City of Sandy

Planning Commission Meeting

Meeting Date: Monday, February 27, 2023

- 8.2. 22-031 DR/VAR/TREE State Street Homes Mixed-Use Development (Quasi-Judicial) 274 - 525
[22-031 DR/VAR/TREE State Street Homes Mixed-Use Development - Pdf](#)
[Exhibit A Land Use Applications](#)
[Exhibit B Narrative](#)
[Exhibit C Plan Set](#)
[Exhibit D and E Lighting Plans and Cut-Sheets](#)
[Exhibit F Stormwater Report](#)
[Exhibit G Transportation Analysis Letter](#)
[Exhibit H Arborist Report](#)
[Exhibit I ODOT Memo](#)
[Exhibit J Indenture of Access](#)
[Exhibit K and L Easements](#)
[Exhibit M Parks Comments](#)
[Exhibit N Fire Marshal Comments](#)
[Exhibit O ODOT comments](#)
[Exhibit P City Transportation Engineer DKS Comments](#)
[Exhibit Q PW Comments](#)
[Exhibit R Third Party Arborist Review](#)
[Exhibit S ODOT Comments State Street Homes pre-app](#)
[Exhibit T Email from ODOT](#)
[Exhibit U Sandy Multi-Family Site Plan Revisions \(rcvd Feb 9, 2023\)](#)
[Exhibit V Dennis Petross Public Comments \(received February 14 2023\)](#)

4 TRASH ENCLOSURE - SIDE

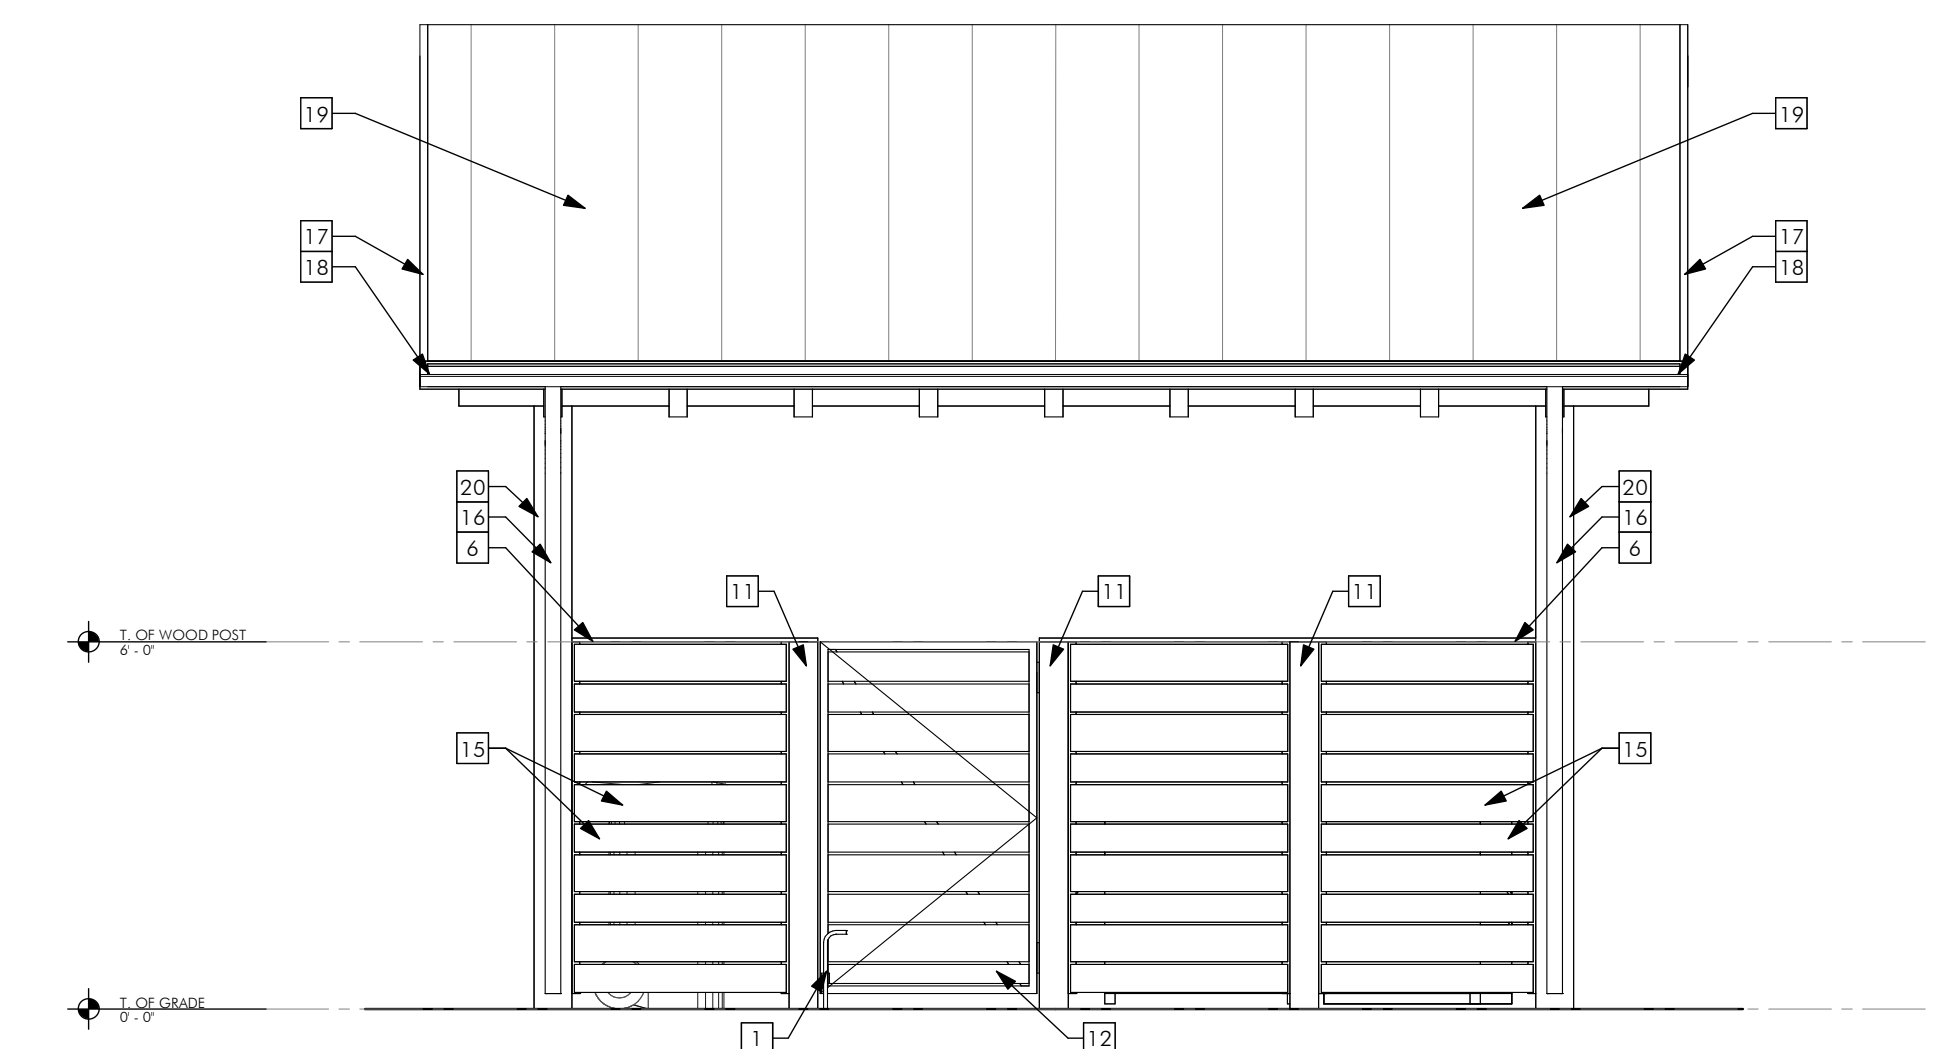
40. Section 17.90.120(J.4) contains standards for trash collection and recycling areas. The applicant proposes a screened garbage and recycling area to the east of the proposed mixed-use building. The submitted Trash Enclosure Elevations (Exhibit C, Sheet A1.03) detail a covered structure with a gabled roof and a 6-foot-tall wall on all four sides designed to match the primary building in compliance with the code. The wall is proposed to be alternating 1-inch by 6-inch and 1-inch by 8-inch horizontal boards with a 1/2-inch gap between each and painted “Gropius Gray” to match the main building with 6-inch by 6-inch pressure treated wood posts. The front (west) and side (south) walls contain gates for access.

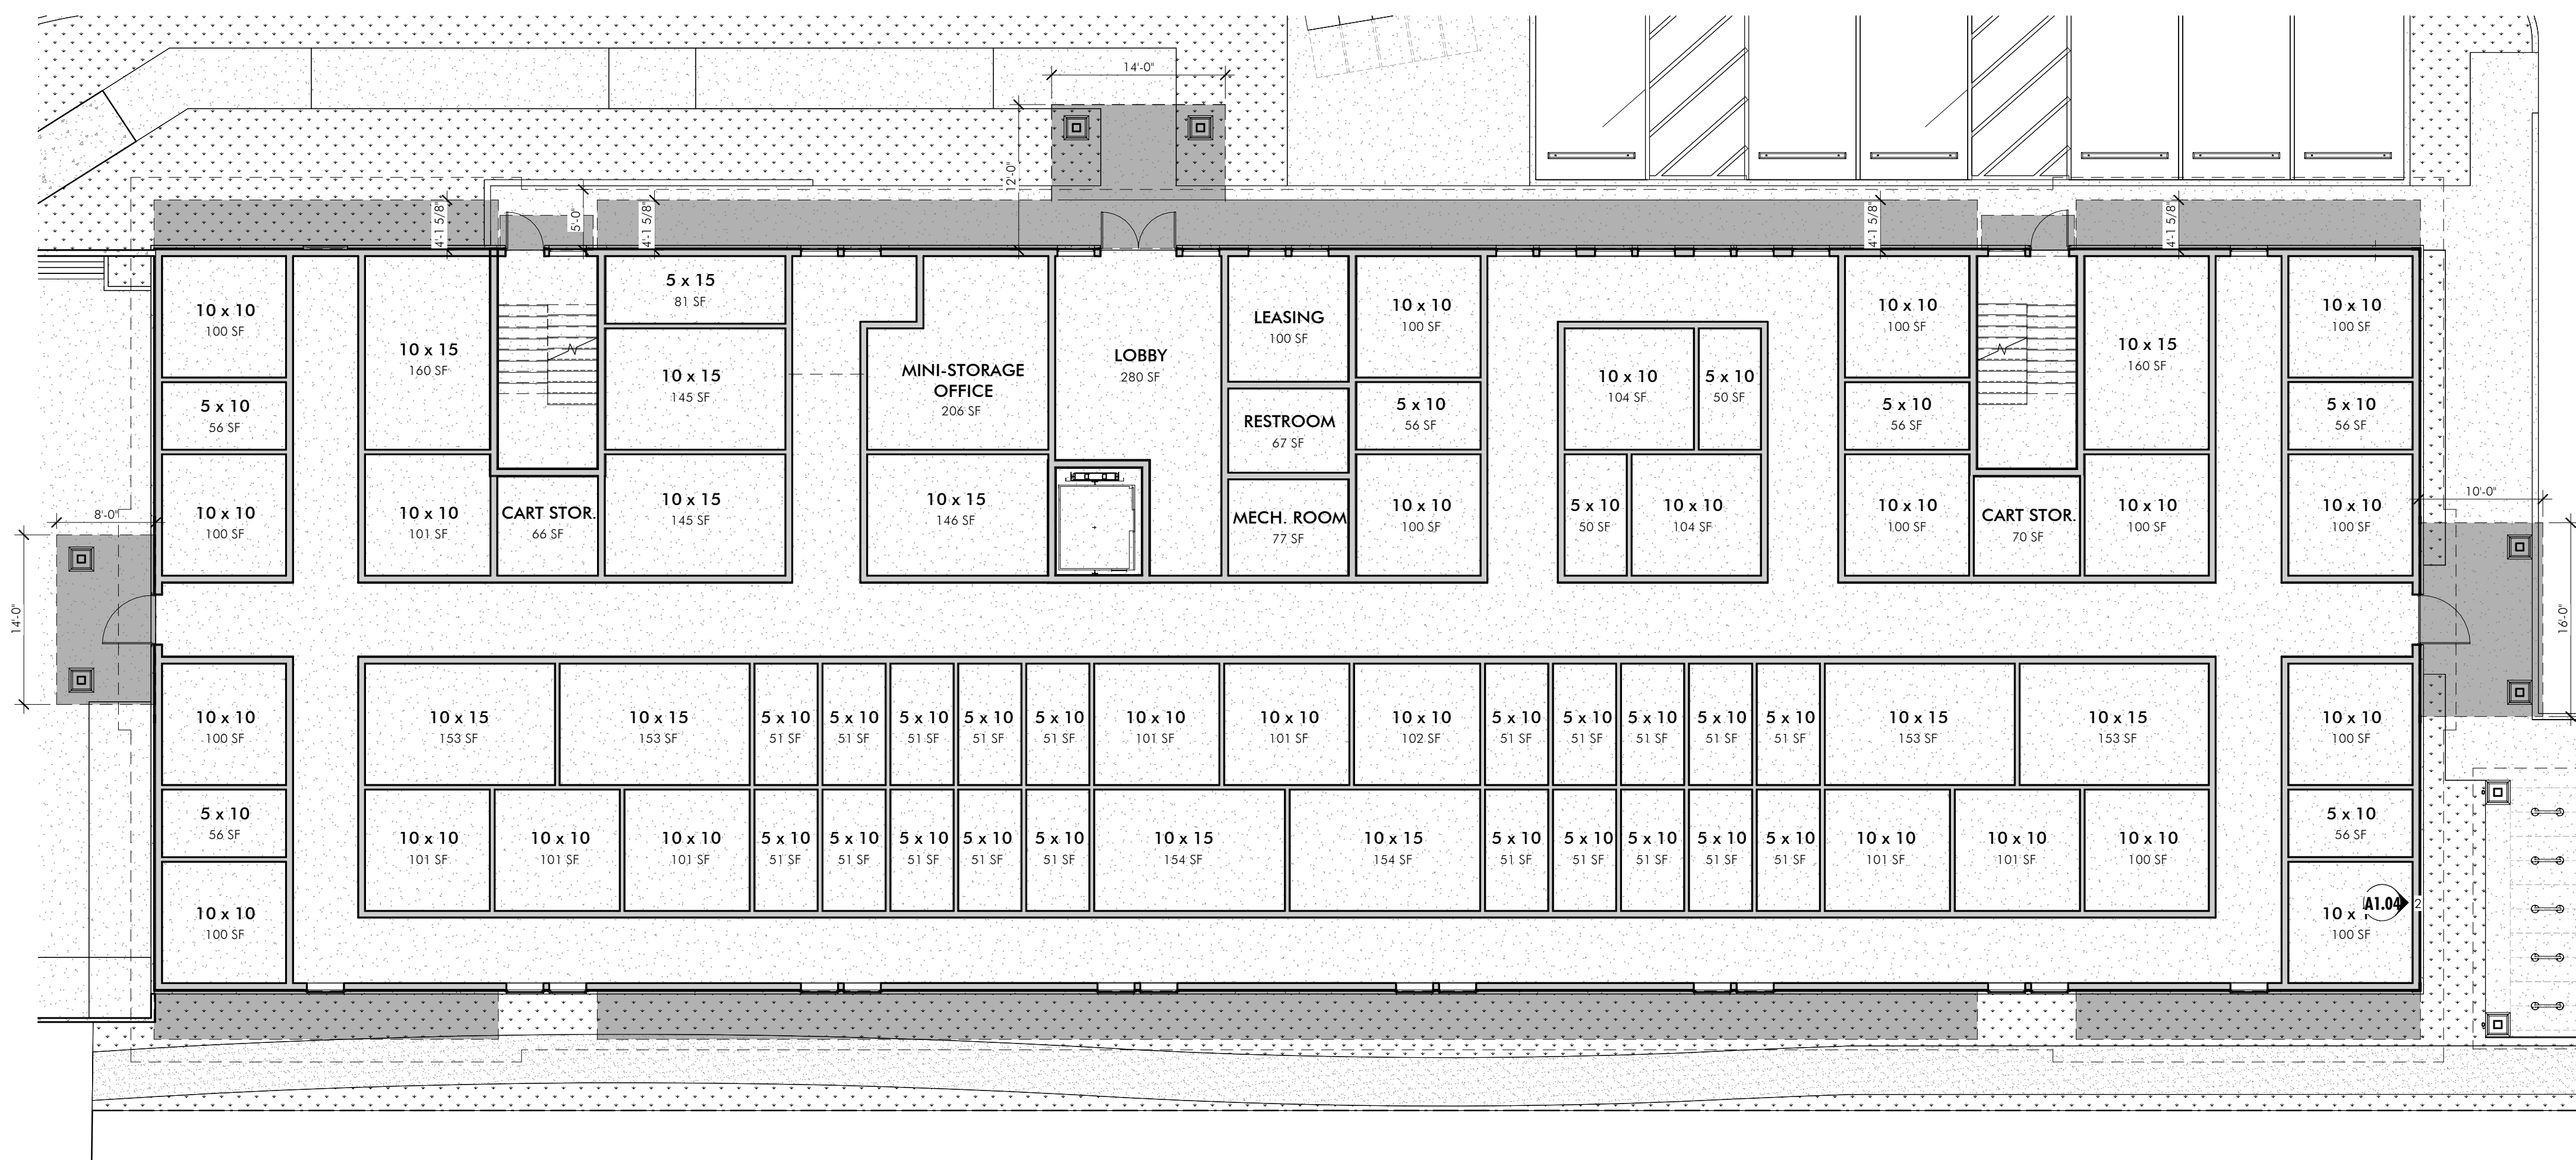
22. Section 17.90.120(C.1) requires gable roofs with a minimum roof pitch of 6:12 on new buildings with a span of 50 feet or less. The proposed building is approximately 190 feet by 69 feet; thus the roof span is greater than 50 feet. However, as stated in the narrative (Exhibit B) and detailed on the mixed-use building Floor Plan - Roof (Exhibit C, Sheet A1.23) and the

trash enclosure (Exhibit C, Sheet A1.03), bicycle enclosure (Exhibit C, Sheet A1.04), and gazebo (Exhibit C, Sheet A1.05), the applicant is proposing a 6:12 roof pitch for all proposed structures.
